**UVALDE**  
**ALTERNATE GROUNDWATER SUPPLY**  
**INFRASTRUCTURE PLANNING REPORT**

**(FINAL)**

RE: Regional Water Supply Facility Grant Contract between the Texas Water Development Board (TWDB) and the City of Uvalde (City); TWDB Contract No. 1348321575, Proposed Subcontract by the City with CDS Muery (CDSm) Draft Report Comments for Alternate Groundwater Supply Infrastructure Planning Report

**TWDB REVIEW COMMENTS – RESPONSE**

### Exhibit 4

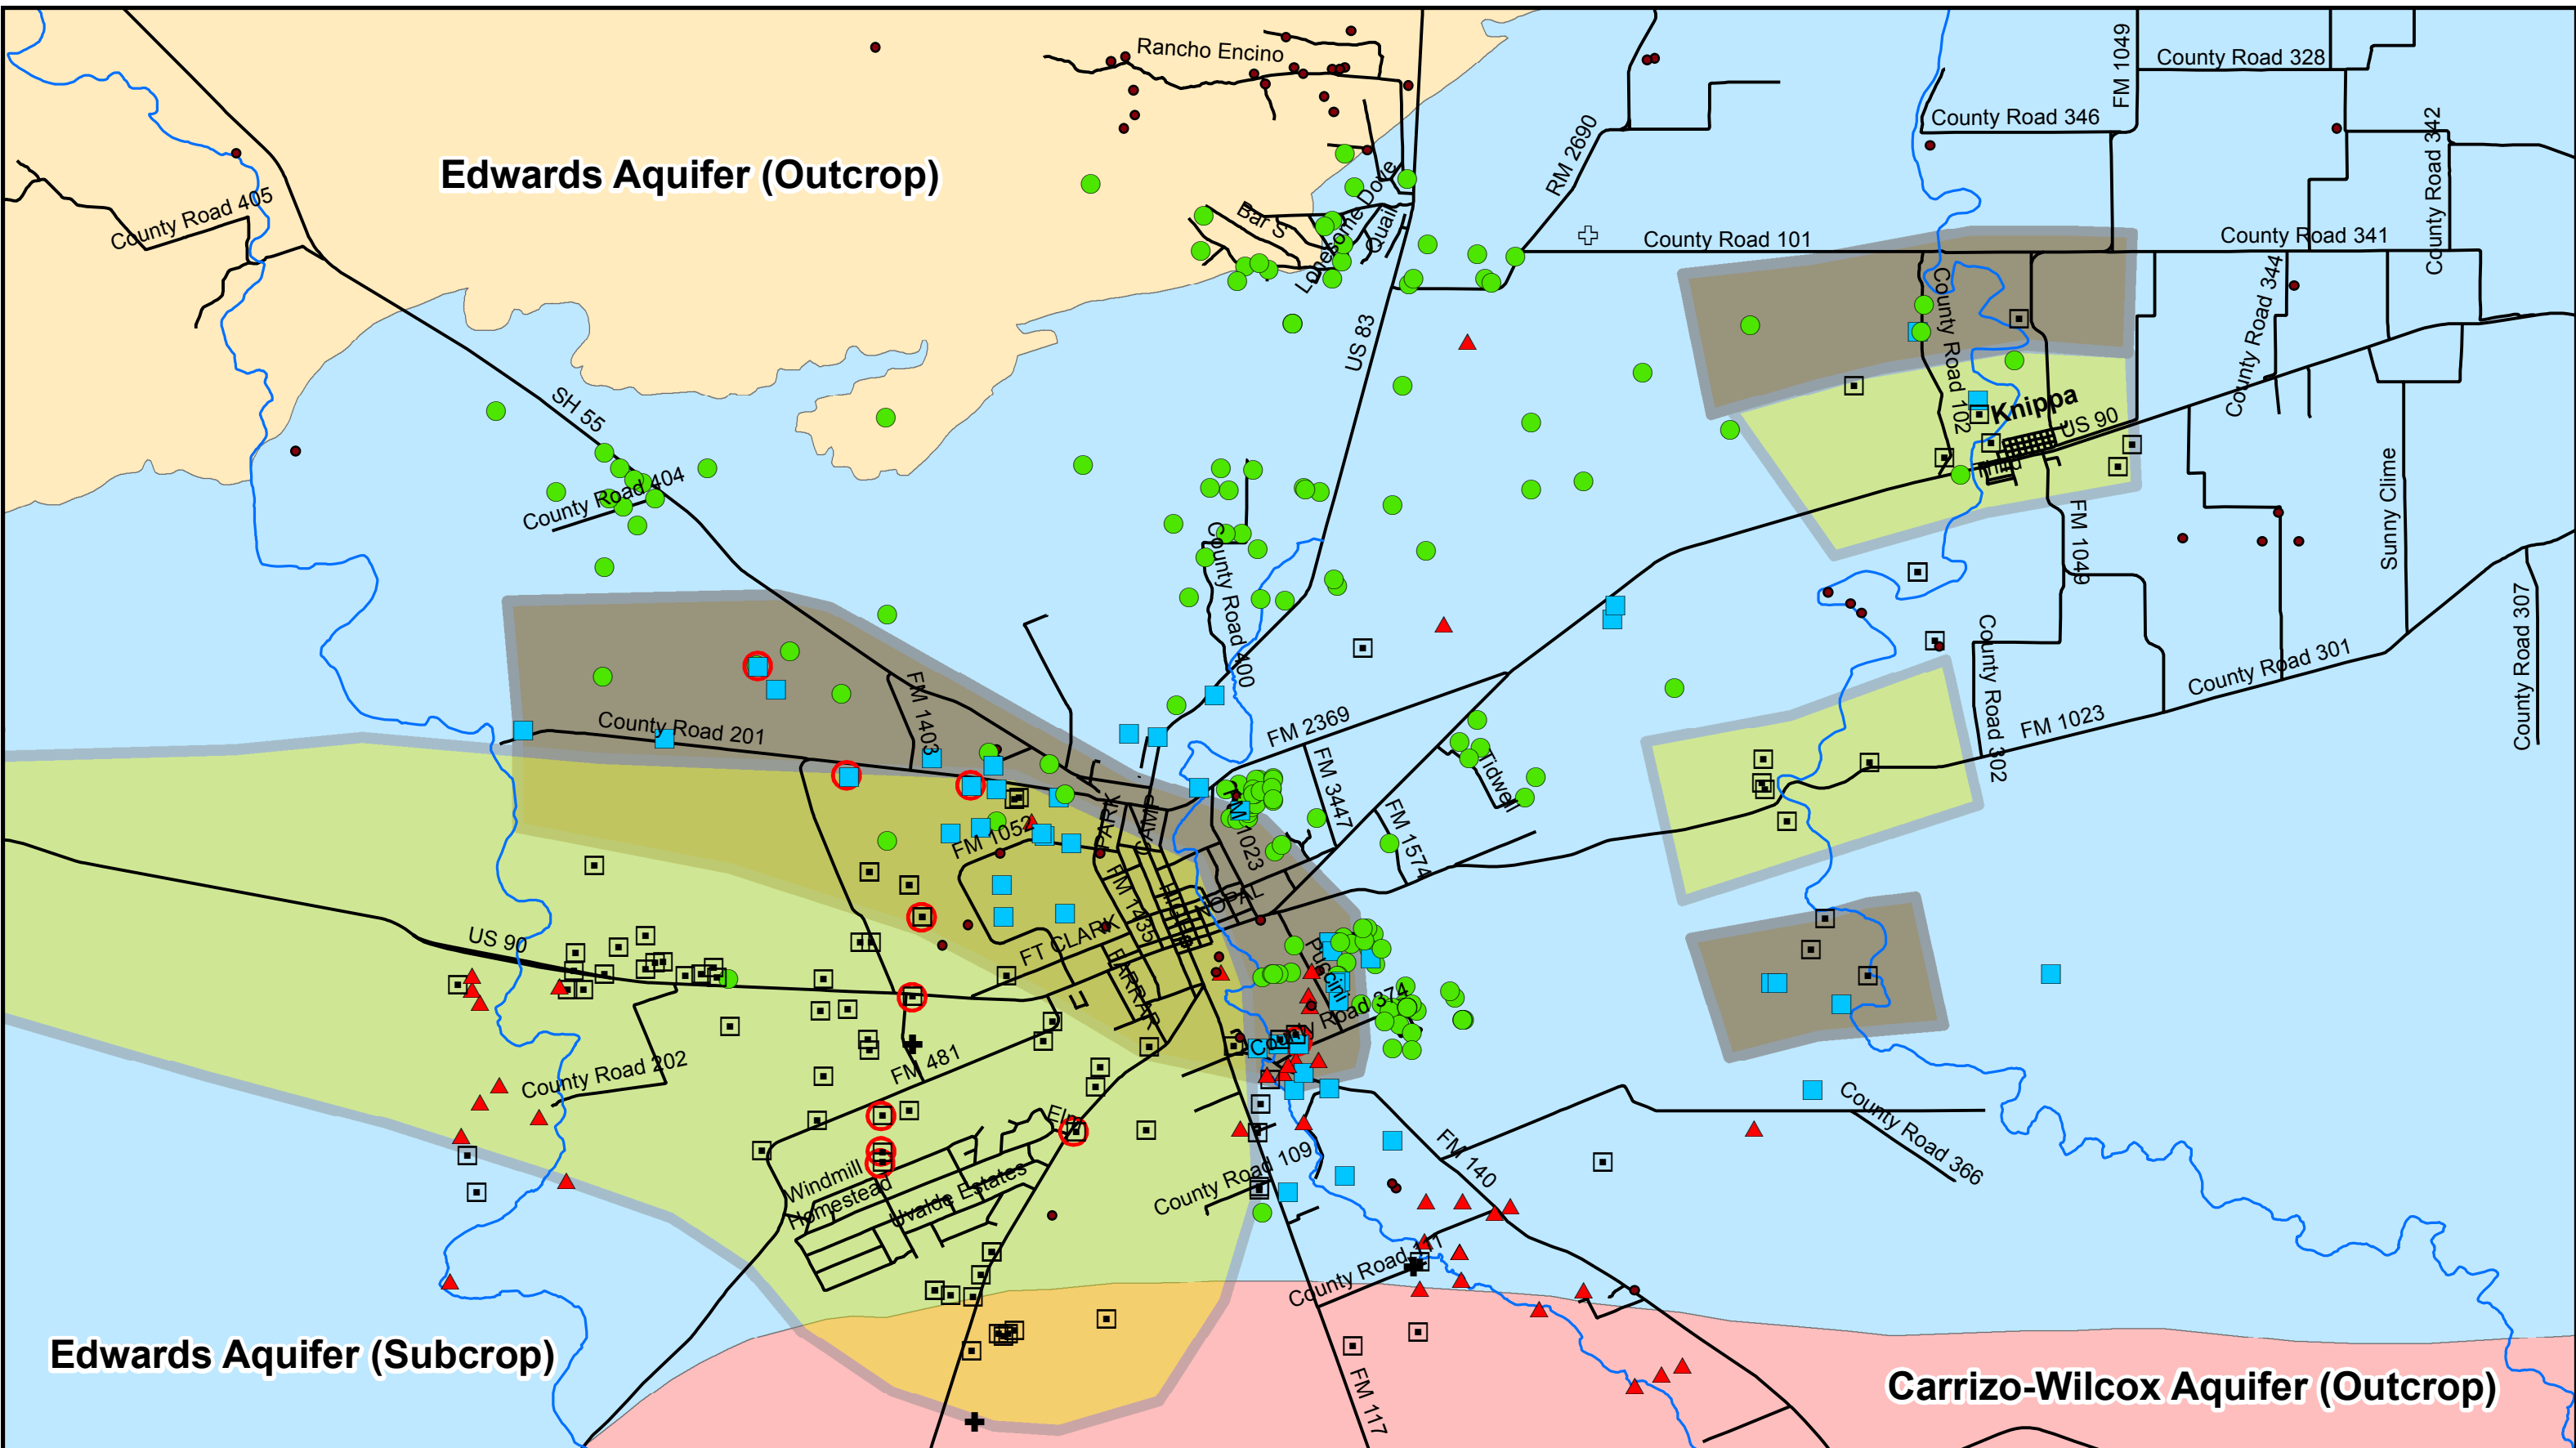
5. Task 400: Please consider identifying in the text, legends, etc. that the well numbers are Well Report Tracking numbers rather than state well numbers.

*Comment 5:* Task 400. Identify that well numbers are TWDB Well Report Tracking numbers.

*Response:* Clarified in text and on Exhibit No.4.
